PROJECT:
DEER PARK GATEWAY

SHEET TITLE
LAYOUT PLAN

L2.1

| SHEET NAME: TOWER WALL & DETAILS | |

2 GATEWAY LAYOUT PLAN

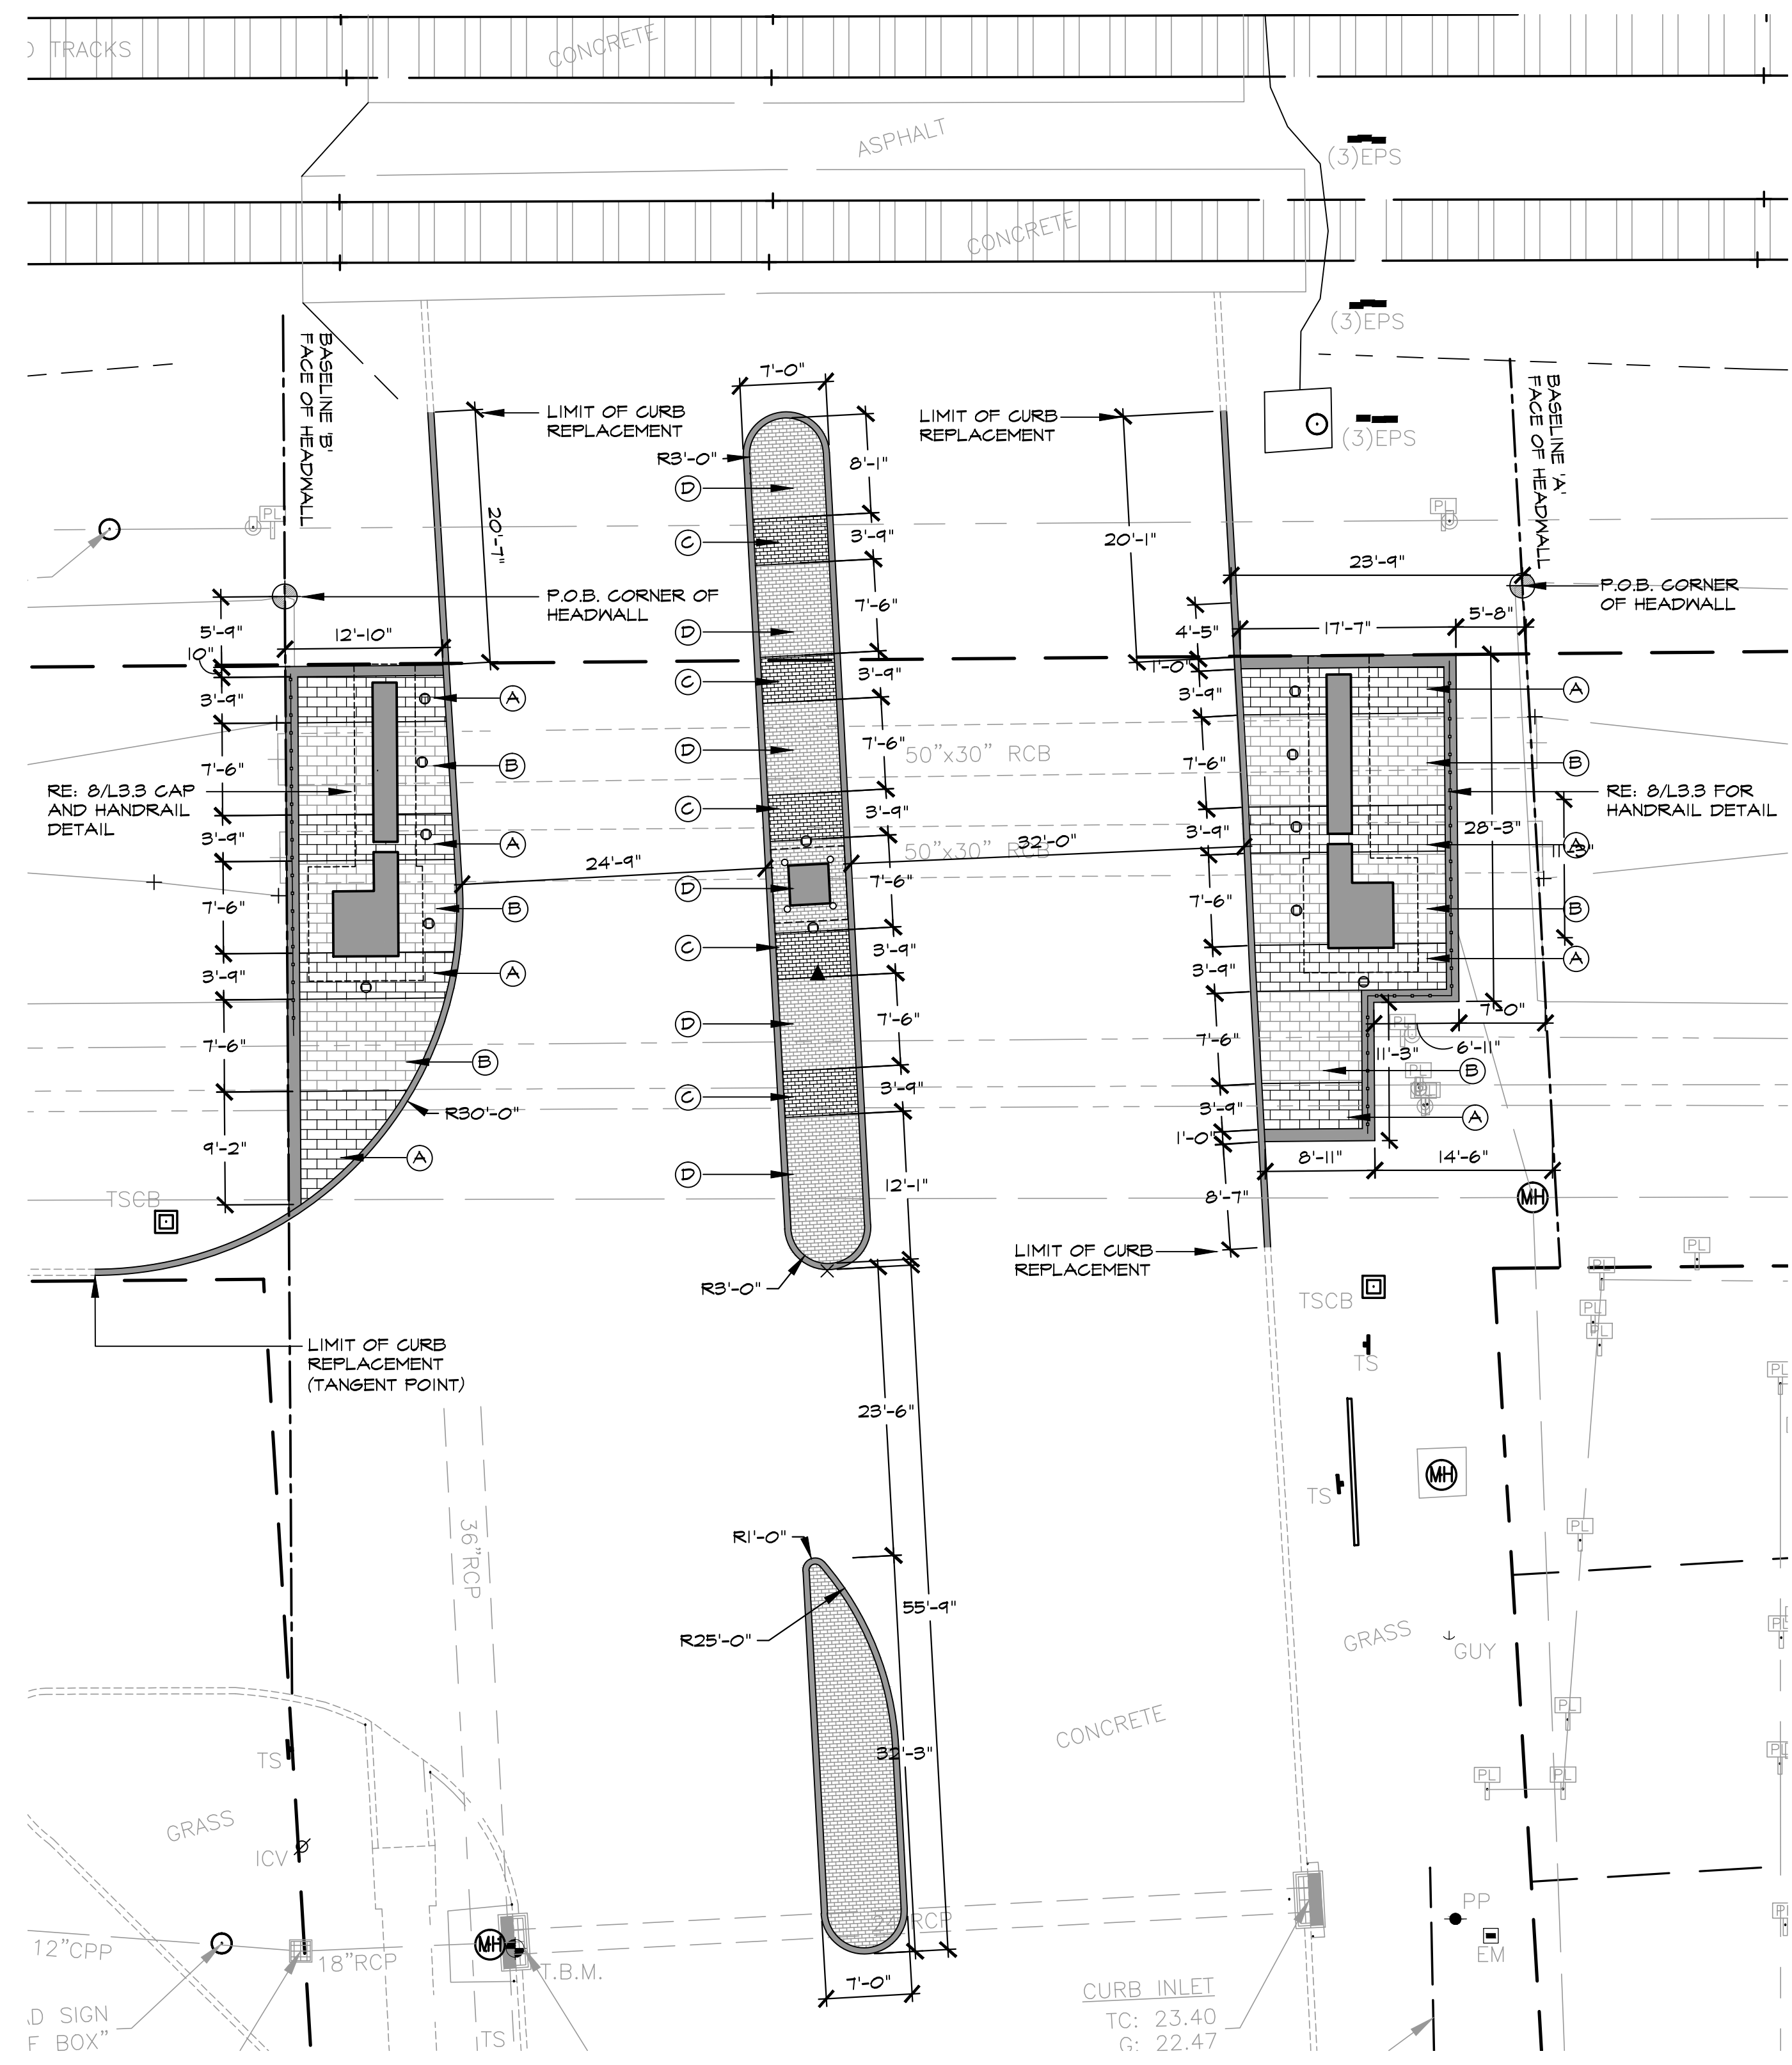
Replacement of stone (205 sf total)
Type A - 90 sf
Type B - 115 sf

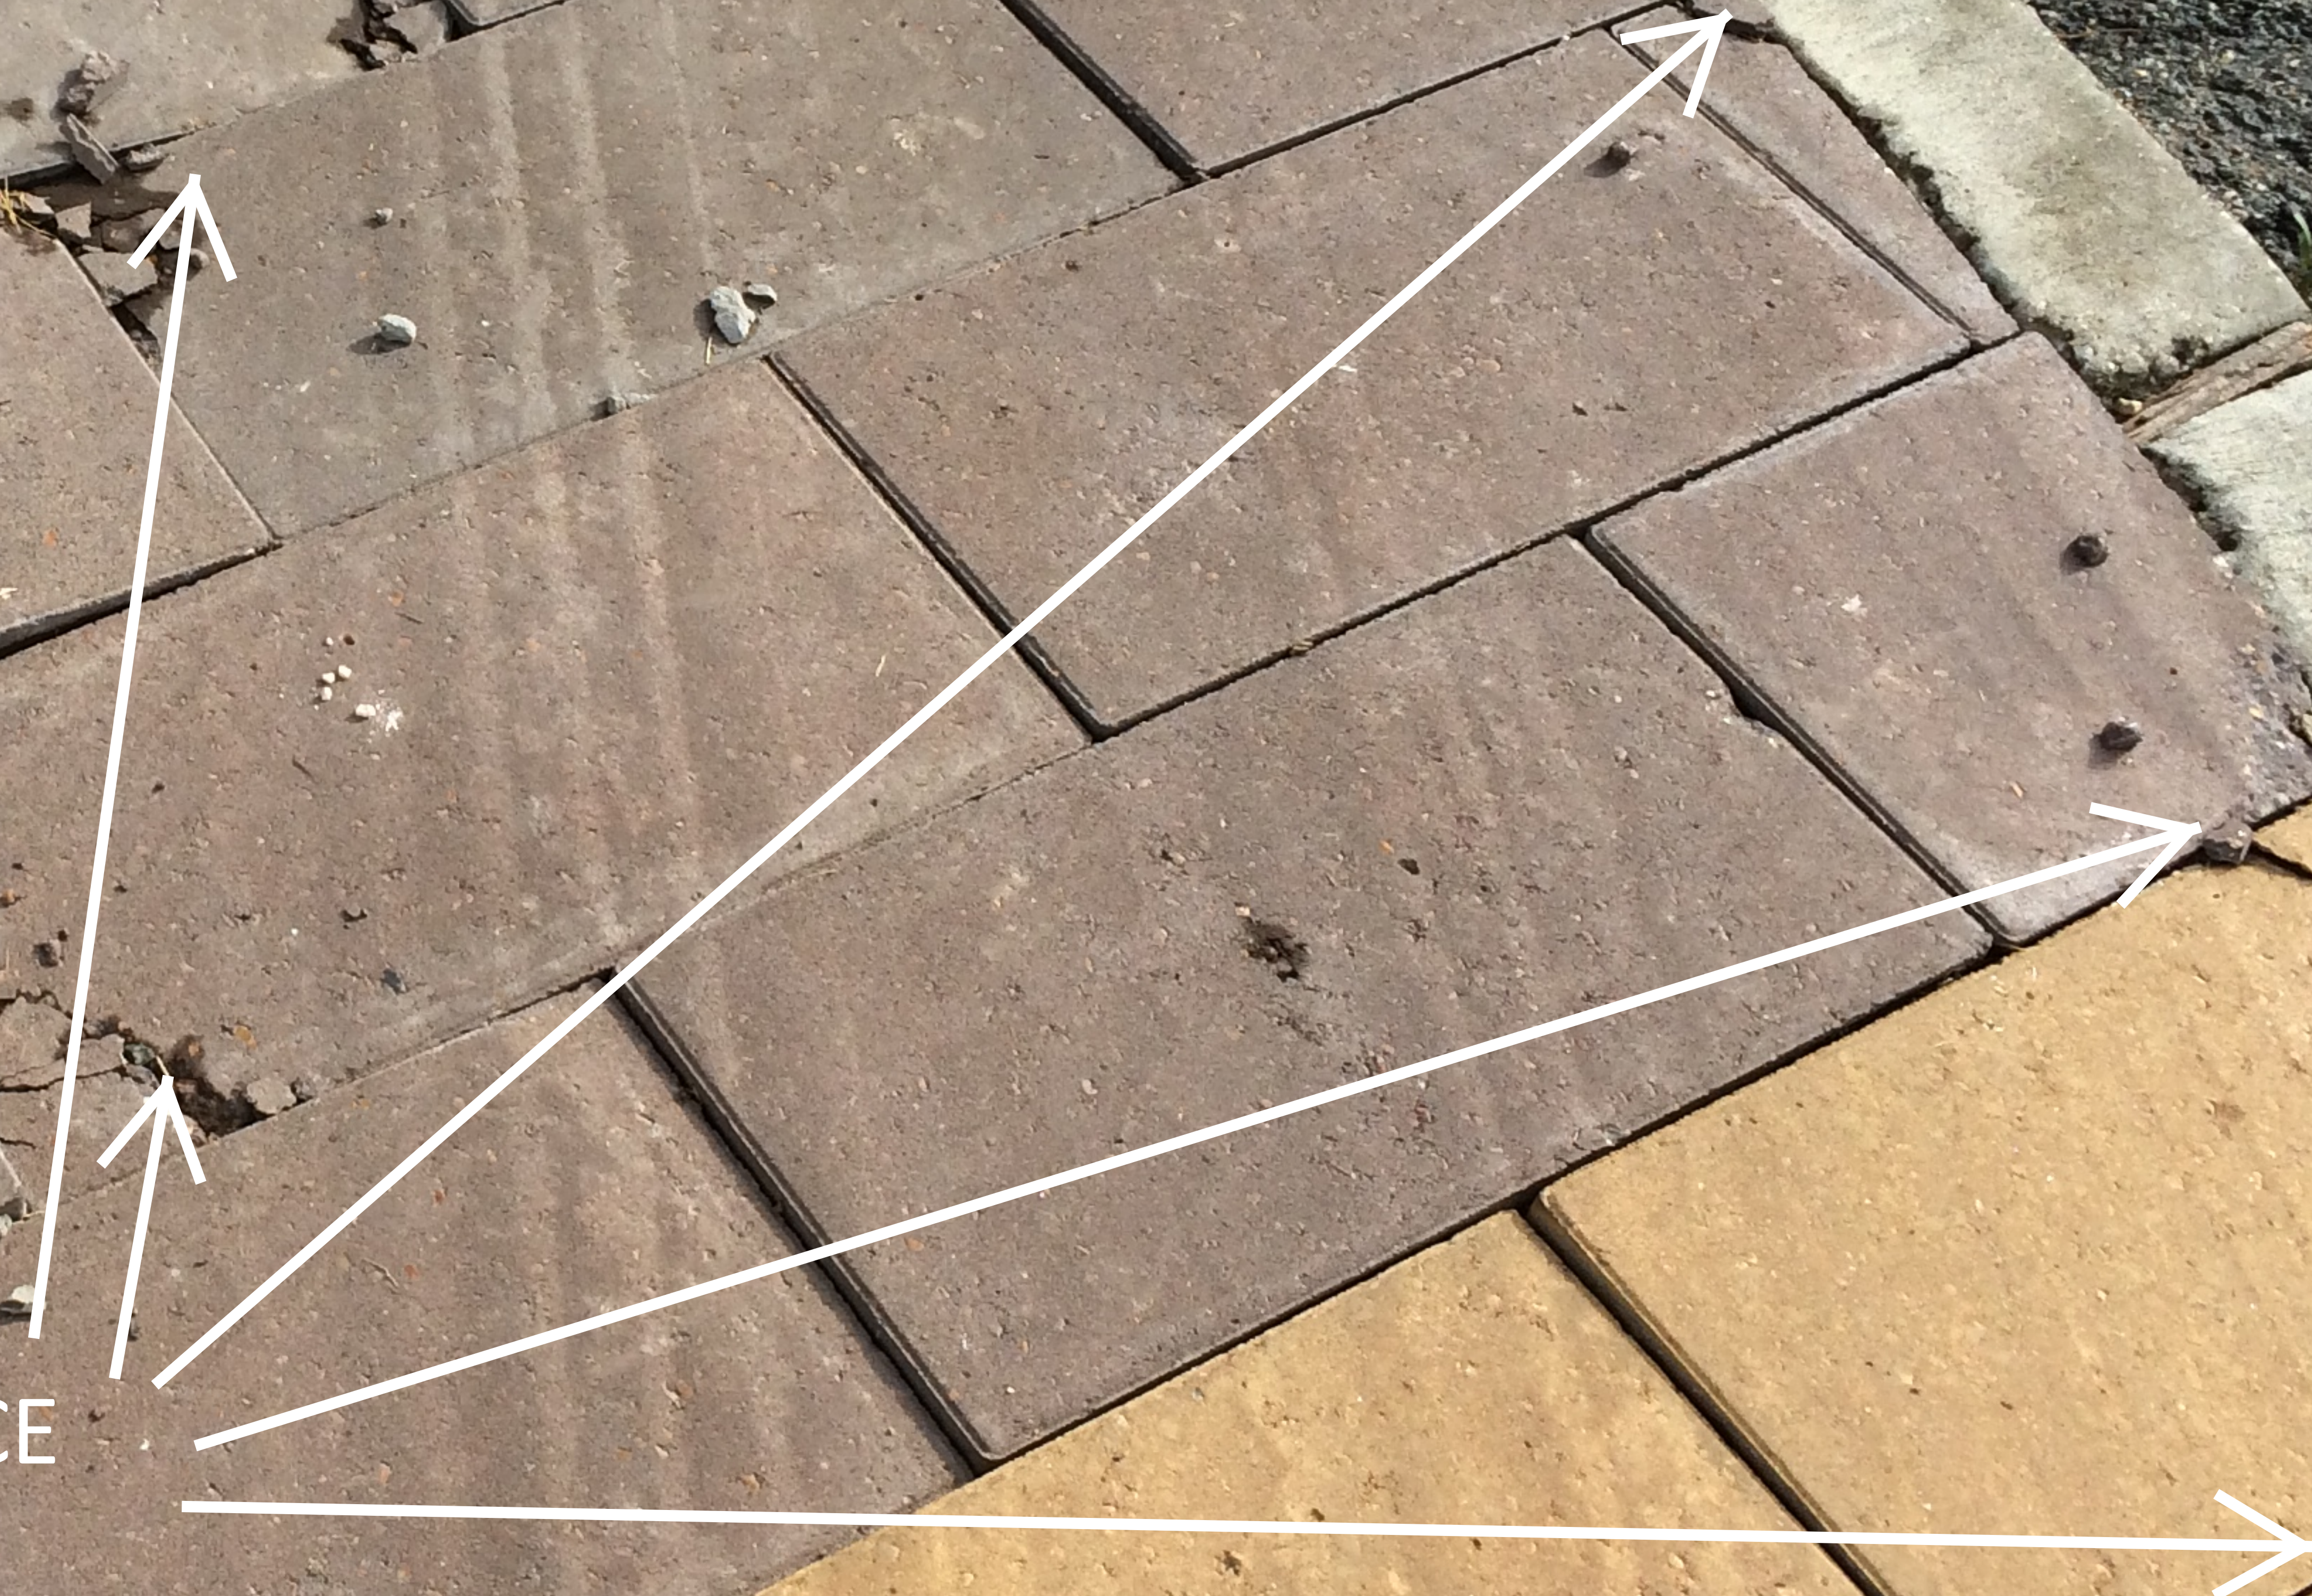
APPROXIMATELY 20-25 PAVESTONE ARE
CHIPPED OR CRACKED. DAMAGE CAUSED
BY TRUCK TIRES

REPLACE CONCRETE
PAVERS FROM THIS
POINT FORWARD

DAMAGE TO CONCRETE PAVERS, SURFACE
CRACKS, CHIPS AND BASE FAILURE

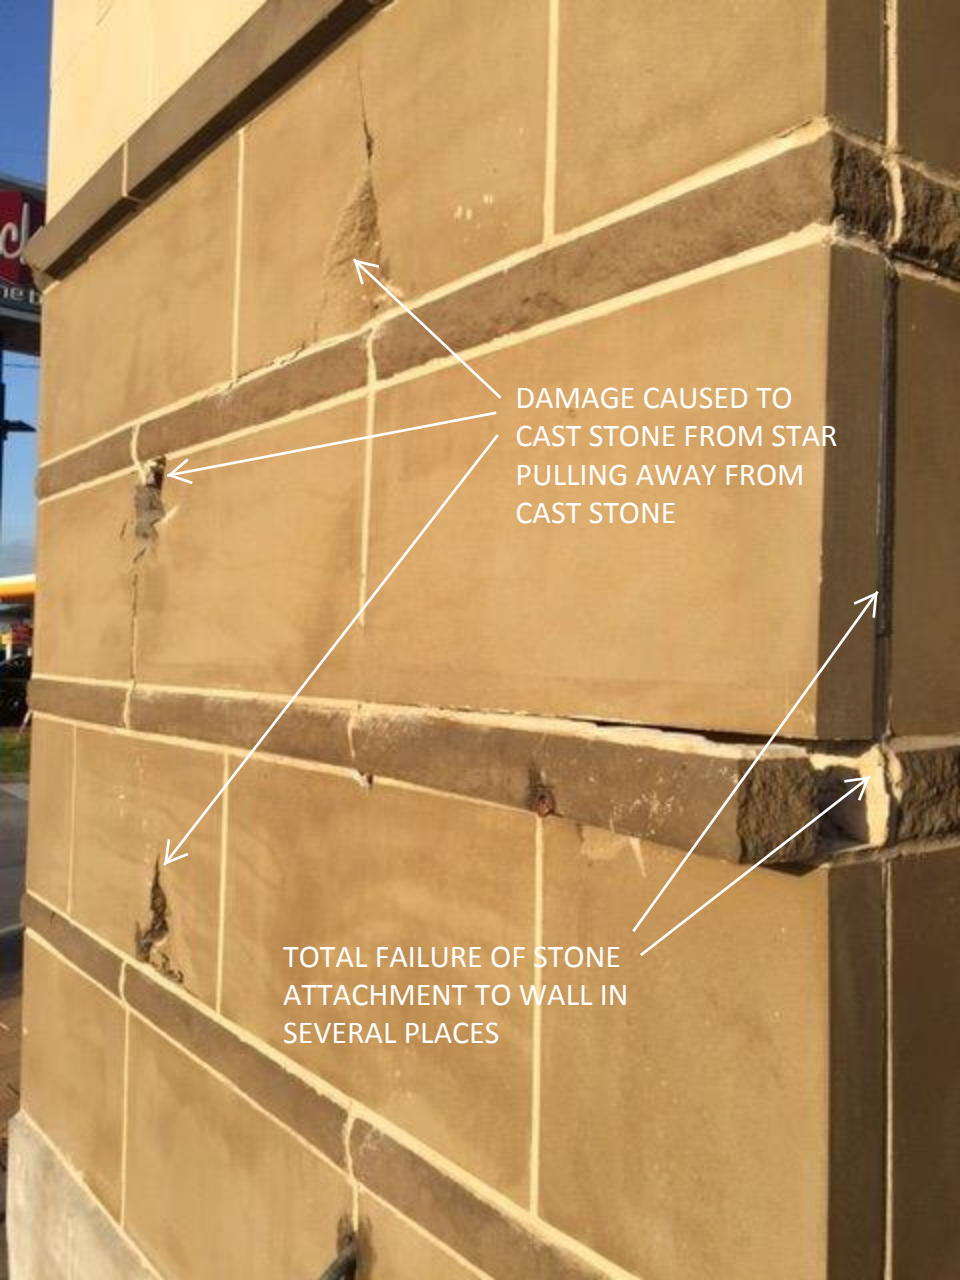
STAR MOUNTING ANCHORS RIPPED FROM WALL CAUSING DAMAGE TO SURROUNDING STONE AND GROUT JOINTS (MULTIPLE LOCATIONS)

DAMAGE CAUSED TO
CAST STONE FROM STAR
PULLING AWAY FROM
CAST STONE

TOTAL FAILURE OF STONE
ATTACHMENT TO WALL IN
SEVERAL PLACES

DAMAGE TO CAST STONE
WATER TABLE/CAP

CAST STONE CAP
HAS MOVED AND
MORTAR HAS BEEN
COMPROMISED

SURFACE SCRAPE ON CAST
STONE - RECOMMEND
REPLACING ENTIRE COLOR OF
THIS STONE ON THIS
ELEVATION TO SO THAT
COLOR REMAINS EVEN.

STEEL STAR WAS
DAMAGED WHEN
DRAGGED BY TRUCK.
METAL EDGE HAS BEEN
DAMAGED. METAL
STUDS DEFOMED STEEL
WHEN RIPPED FROM
WALL. REQUIRES TOTAL
REPLACEMENT
